Location:  
Oak Grove Park  
2400 Barlow Road

Request:  
Major Site Plan

Staff Recommendation  
Approval subject to  
conditions on page 9

Hudson Planning Commission	SITE PLAN REVIEW – INCLUSIVE PLAYGROUND
Case No. 25-1237	October 13, 2025

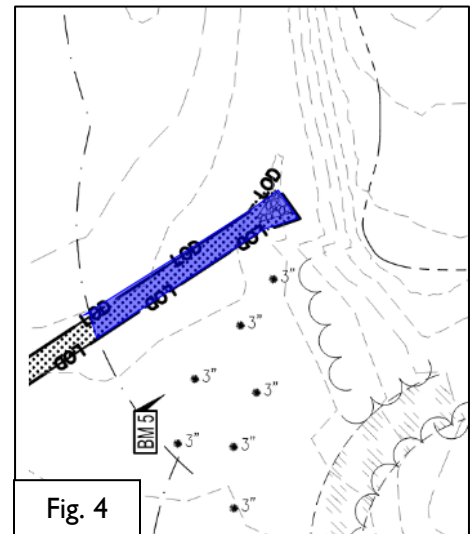
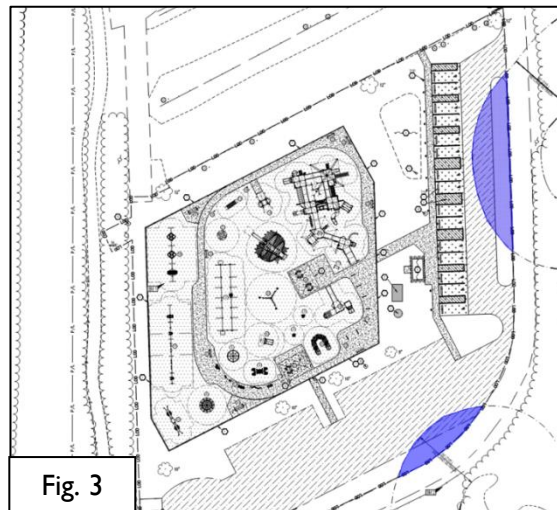
- ✓ **Pedestrian/Bicycle Linkages**  
**1205.04(d)(11)**      *Provision shall be made in the design of all developments for non-vehicular circulation systems, including but not limited to sidewalks, pathways, and bikeways.*  
Staff Comment: Staff notes there is an adjacent multi-purpose path along the western portion of the proposed playground with a connection to the existing gravel parking lot at the southwest corner of the project area (See Figure 1).

Suggest a paved connection be added to the project scope to establish a direct connection to the playground as depicted in Figure 2.

1. Provide an additional pedestrian/bicycle path linkage as depicted in Figure 2 of this staff report.
2. Revise the design of the fence to comply with the requirements of the City's Architectural Design Standards in Appendix A.

Fig. 6

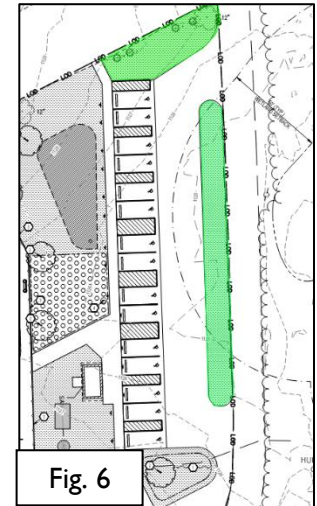
Staff Comment: Suggest additional plantings be incorporated in the seeded areas highlighted in Figure 6 to meet this requirement.

3. Provide additional plantings as depicted in Figure 6 of this staff report.
4. Obtain a variance to Section 1207.11 – Adequate Public Facilities for the proposed restroom building to be served by a water well and septic.

Fig. 7

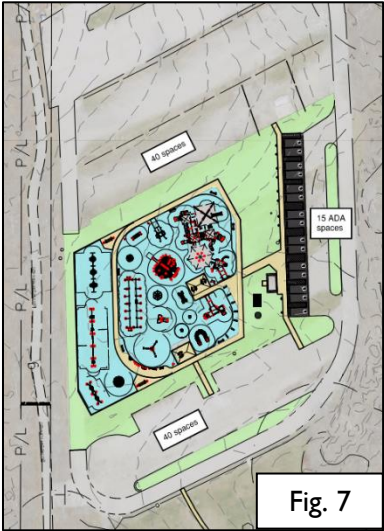
Staff Comment: Staff notes the parking table in section 1207.12(f) does not specify the required number of spaces for the park use category. The existing gravel parking lot provides approximately 290 parking spaces. The proposed playground would remove approximately 130 spaces, leaving approximately 160 spaces post construction. The proposal would also provide 15 newly paved ADA spaces. Figure 7 depicts the immediately adjacent parking spaces post construction.

Staff notes the parking area would be shared among the proposed playground, southern ballfields, and Jaycees haunted house. Staff recommends the submitted parking analysis be revised to document further how the playground parking needs interact with the needs of the ballfields and the Jaycees haunted house.

5. Provide additional parking lot paving as depicted in Figure 8 of the staff report.
6. Update the *Trip Generation and Parking Analysis* report to document the following:

- a. How the playground parking needs interact with the needs of the ballfields and the Jaycees haunted house.
  - b. Any potential impacts to the Barlow Road traffic pattern.

Fig. 8

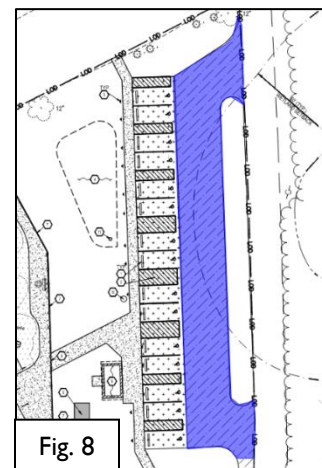
Staff Comment: Acceptable. Each parking space would be surfaced with standard duty asphalt. Staff notes, however, the parking aisle adjacent to the stalls would remain the pre-existing gravel. Recommend the area highlighted in Figure 8 also be standard duty asphalt to better accommodate the special needs visitors.
